WILLIAMSON COUNTY, TEXAS

CHANGE ORDER NUMBER: 1

Project: T5045

CR 404 Hutto Water Line Williamson County Project No. T5045

CR 404 Hutto 24" WATER LINE
TAYLOR, TEXAS
14+00 TO 18+00
WATER LINE C PLAN AND PROFILE

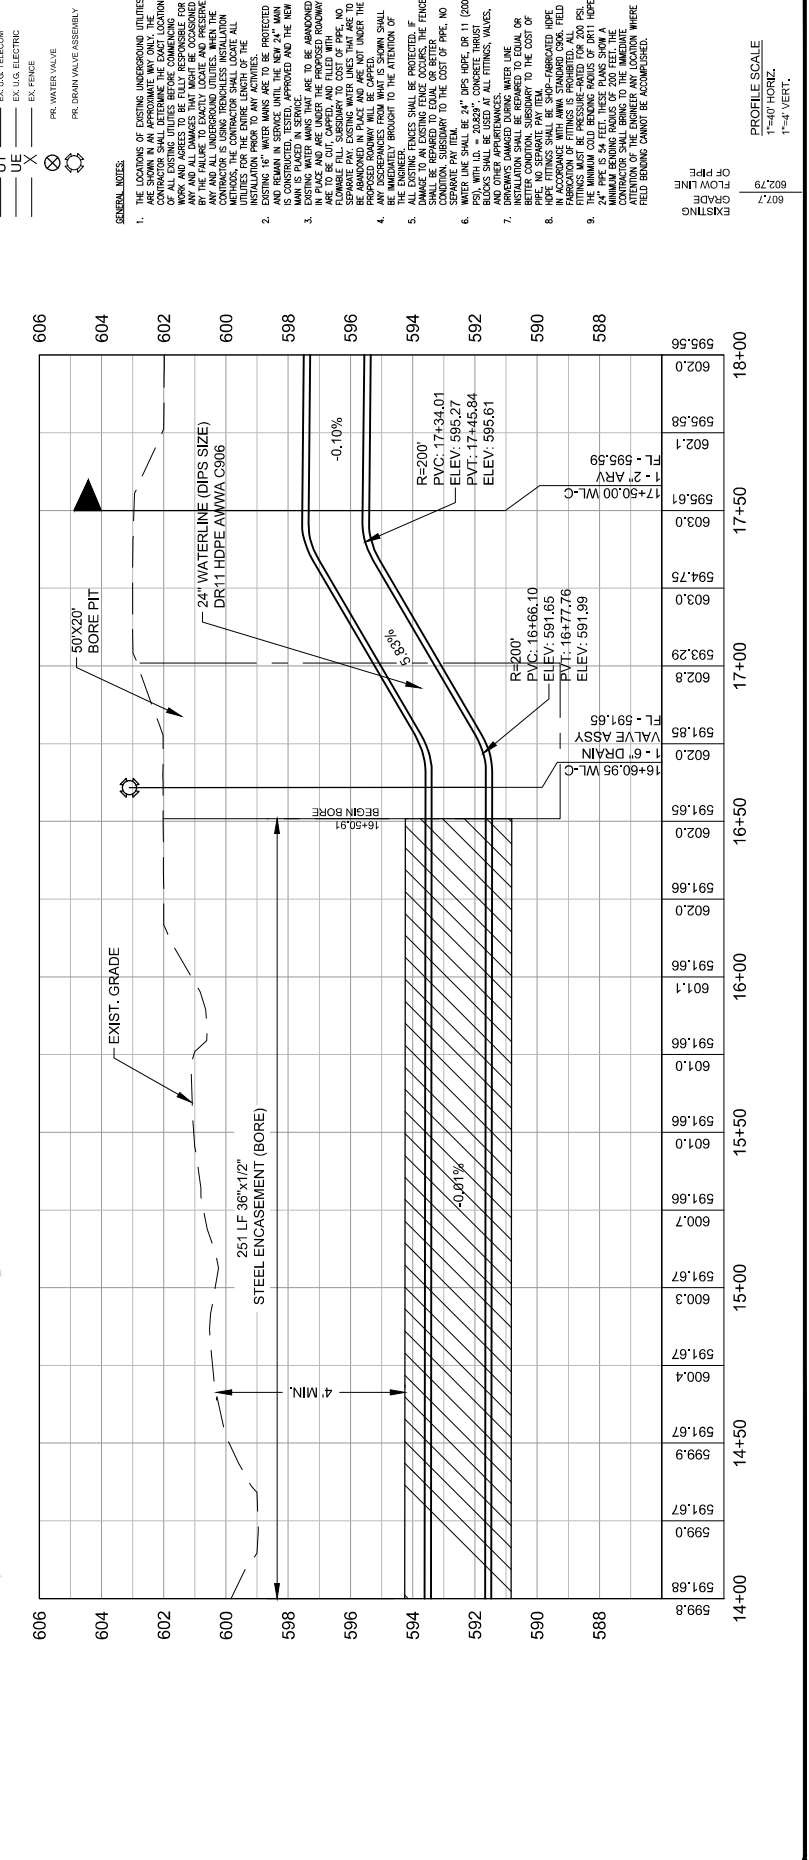
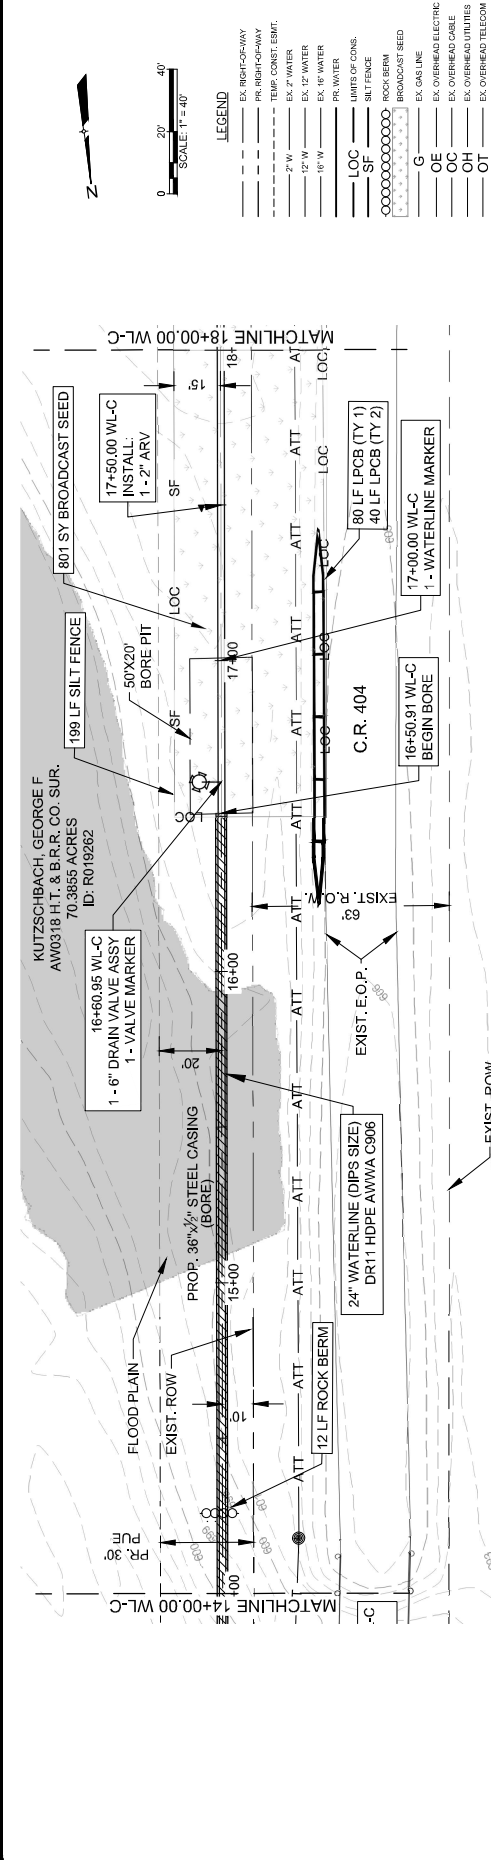
3F. County Convenience. Additional work desired by the County. This Change Order revises the original water line pipe design from 18 inch ductile iron to 24 inch HDPE pipe. Due to the Contract value of this requested change, the 24 inch HDPE pipe material and the fusion of that pipe is also being removed from this Contract and will be bid under a separate Contract. Portable concrete traffic barrier (CTB) is also being added to the Contract, to improve the work zone safety.

This Change Order revises the original water line pipe design from 18 inch ductile iron to 24 inch HDPE pipe. The change in pipe size and material was necessary to meet the increased demand in water and to alleviate the availability issues of ductile iron pipe. Due to the Contract value of this requested change, the 24 inch HDPE pipe material and the fusion of that pipe is also being removed from this Contract (T5045) and will be bid under a separate Contract (22IFB96). Portable concrete traffic barrier (CTB) is also being added to the Contract, to improve the work zone safety.
